The first draft of the Environmental Assessment contains a number of errors, omissions and inadequacies which must be addressed prior to any decision-making.

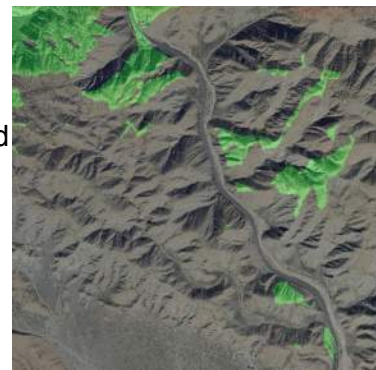
1. Wildfire risk was a concern raised by the community during the Public Scoping period, but it is not addressed in the EA. The proposed project has a potential to increase the wildfire risk in an already very high fire hazard and wind-prone area due to the:
 - a. inclusion of 3,000 gal of fuel storage near homes;
 - b. 196' tall tower as an obstacle to air support during a wildfire;
 - c. far distance to an existing fire hydrant - over 1500' host pull from Matzene and Manana;
 - d. scarcity of resources (personnel, water, pressure); and
 - e. likely increase in unauthorized OHV.
2. Below photographs from Hess Fire on May 15, 2024 show low-flying aircraft and proposed project site from the same stationary vantage point at Conejo Rd/Hess Blvd;

Panorama from Hess Fire (above) and with Google Earth overlay representing height of tower as yellow line (below), based on tower coordinates of 34°2'29.69"N, 116°35'47.71"W and height at 3054' AMSL, demonstrating the potential for tower to interfere with aerial support during fire suppression efforts

11-6-2023, from 11568 Pinon Ave looking west with project site located on top of ridge

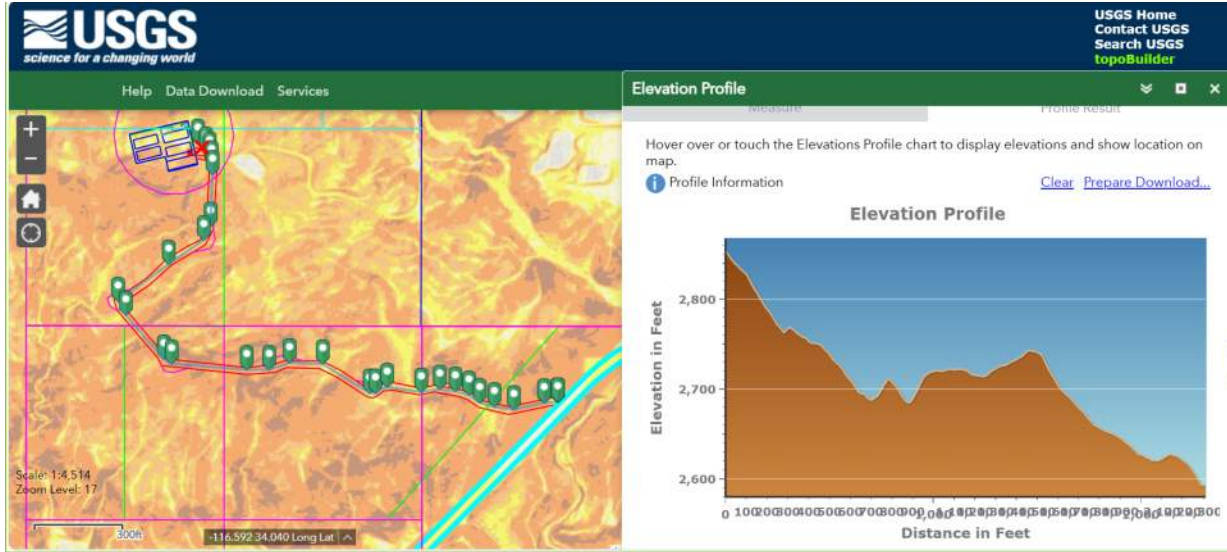
14. DRECP CMA SRMA-VEG-1 incorrectly mentions an OHV Open Area, but project parcels are in an area with limited OHV access, with no designated routes.
15. Appendix F, Biology Report, Section 4.4.5 incorrectly states the site is currently only 2% vegetated. Vegetation communities have recovered significantly since the 2016 and 2021 surveys.

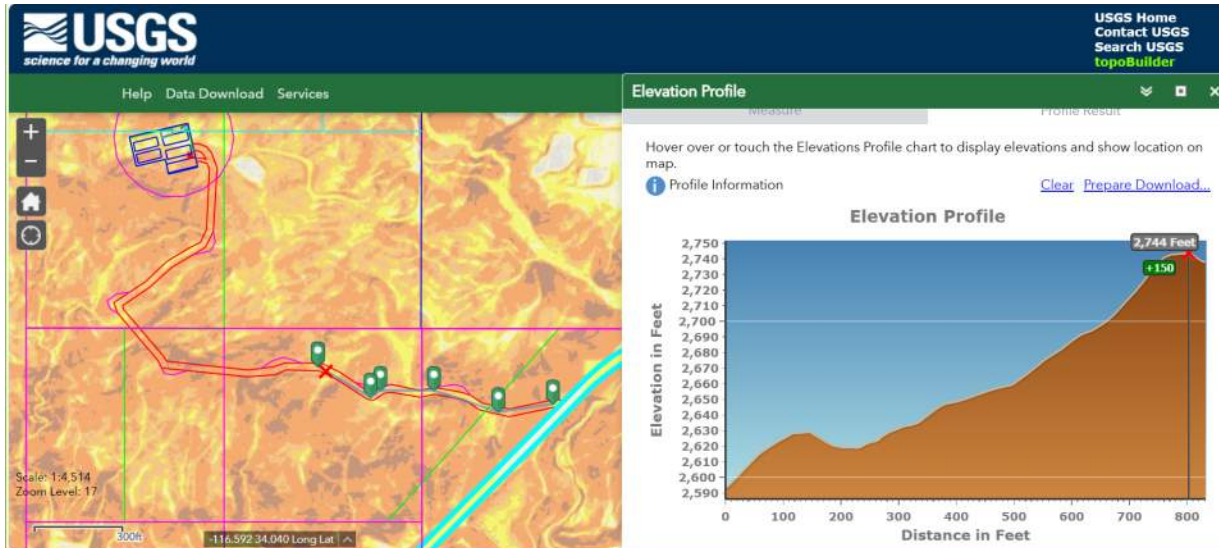
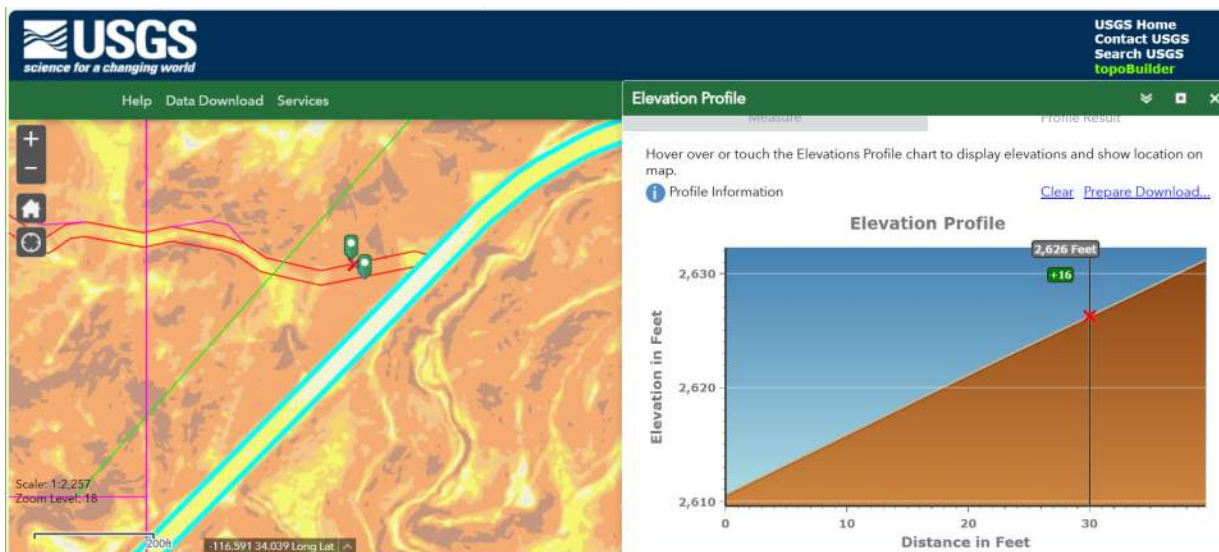
5. Table 3-2 in Environmental Assessment Section 3.4 mentions slopes of 5-15%. The slopes within the proposed ROW were measured to be up to 33 %. These slopes were measured several different ways:

The proposed tower site is 262 feet higher than the proposed road start at Canyon House. The proposed access road would be about 2,347 feet long. If we averaged this slope, it is about 1 foot gain per 11 feet of road, or 11% grade. However, we can see that the slope is not constant. If we map from Canyon House just a bit up the proposed ROW, we see that the ROW would gain 33 feet within the first 100 feet from Canyon House Rd. and about 150 feet within the first 800 feet from Canyon House Rd (see figure below). This is a 33% and 18.75% slope, respectively. This slope is just what the road will cross, which is not necessarily the steepest slope direction. The steepest slopes are over 50%.

Above: the same map layers as the other USGS map, but with the elevation profile taken the opposite direction as the proposed ROW direction.

Above: the same map layers. This time, the slope was taken across the proposed ROW to show an example of slope steepness along where the ROW is proposed to be built.
